Subject: Response to Requests for Additional Information on Topical Report
CENPD-404-P, Rev. 0
(Contains Proprietary Information)

QUESTIONS ON CENPD-404-P ZIRLO™ CLADDING IN CE FUEL ASSEMBLY DESIGNS*

CENPD-404-NP-A

Figure 3.4-2 ZIRLO Measured Oxide Thickness vs. Modified Fuel Duty Index

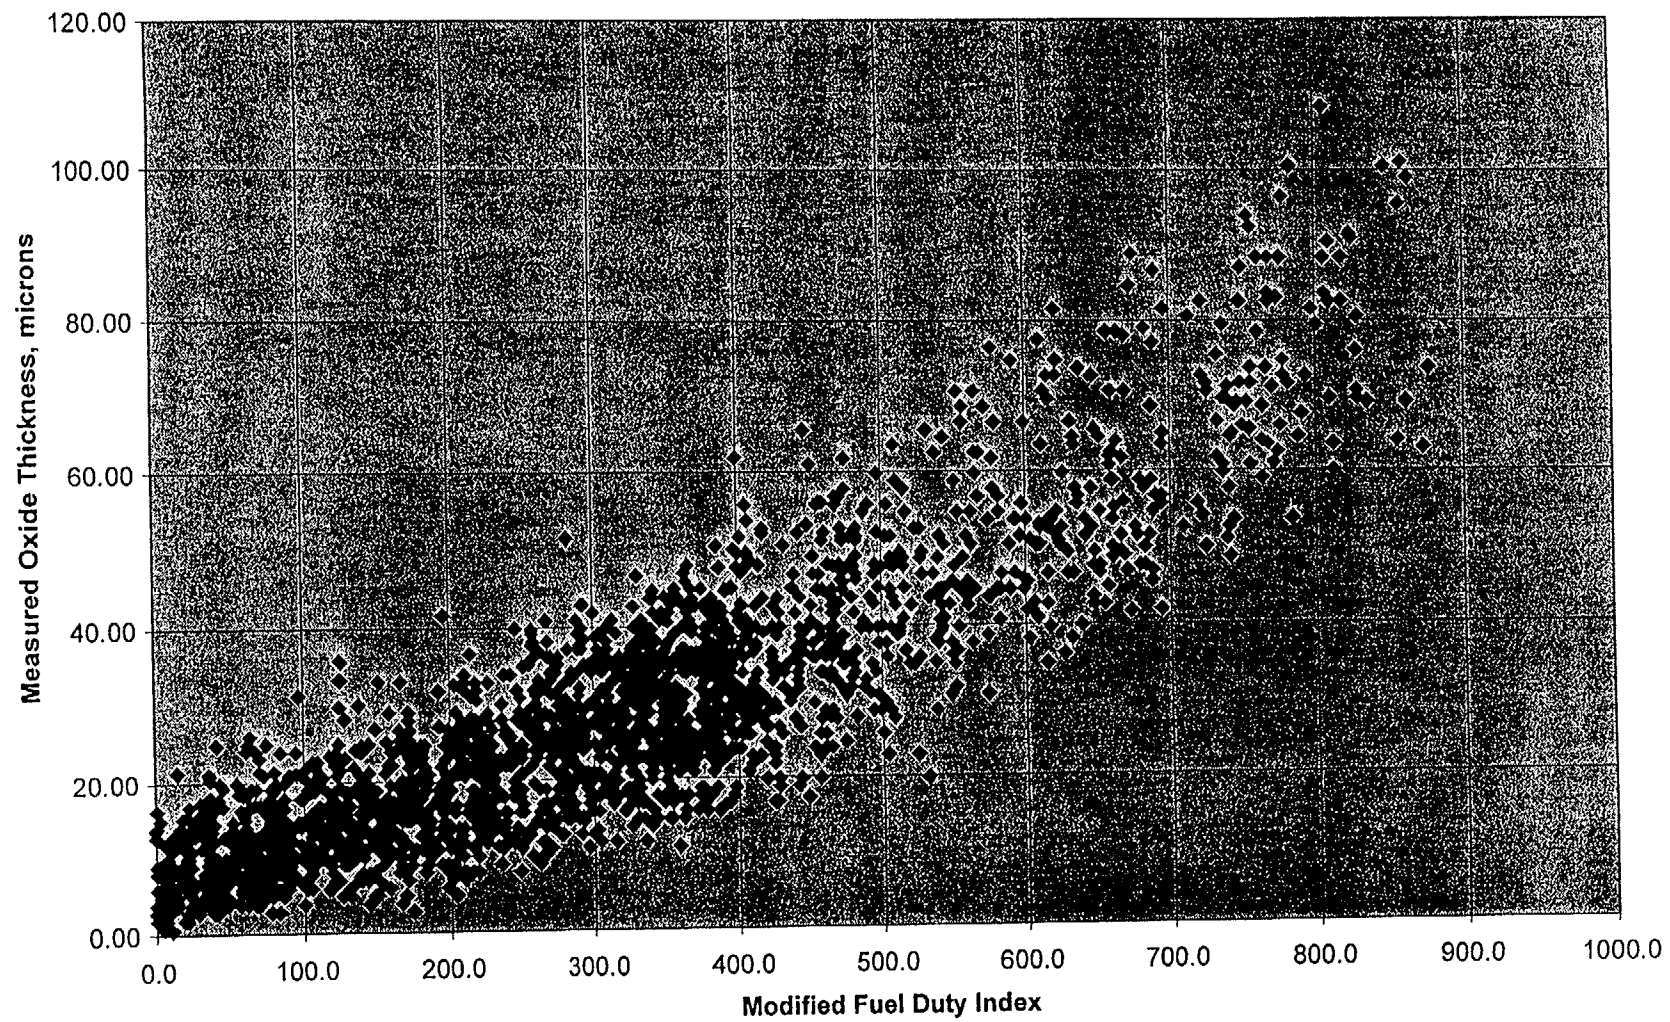
Figure 3.4-2 on page 18 of CENPD-404-P, shows modified fuel duty index vs. measured oxide thickness. Please provide the details of the measurements shown. Will the CE plants limit fuel duty index until actual corrosion data is obtained for ZIRLO™ in CE plants?

Table 1-1 provides a summary of the fuel rods for the ZIRLO™ corrosion database shown in CENPD-404-P Figure 3.4-2. For each fuel rod, a modified Fuel Duty Index (mFDI) was calculated at the location of the measured maximum oxide thickness in each grid span. Therefore, for a given fuel rod several points may be plotted in Figure 3.4-2 based on the number of grid spans measured for oxide thickness. The mFDI model is described in CENPD-404-P Section 3.4 and in the response to Question 11.

Westinghouse's current calculations show that the maximum mFDI experienced to date for CE designed 14x14 and 16x16 fuel is well within the ZIRLO™ database defined in Figure 3.4-2. Typical maximum mFDI values given in CENPD-404-P Section 3.5 are [] for 14x14 fuel and [] for 16x16 fuel. These maximum mFDI values are not operating limits but were calculated to demonstrate where CE designed fuel falls within the ZIRLO™ database for Westinghouse designed fuel. The engineering implementation of ZIRLO™ cladding for CE designed fuel will demonstrate that the mFDI and best estimate oxide thickness stays within the bounds of the ZIRLO™ database defined in Figure 3.4-2.

Oxide thickness will be measured on selected rods with the highest mFDIs to assure that actual corrosion performance is following the expected behavior shown in Figure 3.4-2. These measurements will be made on typical high duty fuel assemblies after second and third cycles of operation. For the initial batch implementation of ZIRLO™ the mFDI will be restricted until further data is obtained to verify corrosion performance. The interim mFDI restriction will be set so there is adequate corrosion margin with the use of ZIRLO™ compared to the use of OPTIN cladding and there is sufficient margin in the mFDI restriction to accommodate for uncertainties in core design (e.g. cycle length, plant operating conditions, etc). The mFDI restriction will be established by each licensee and addressed in the site specific submittal to implement the ZIRLO™ topical. The interim fuel duty restriction will be dropped or modified after measurements are obtained. The mFDI model may also be modified to assure accurate behavior for future fuel duty predictions after data is obtained.
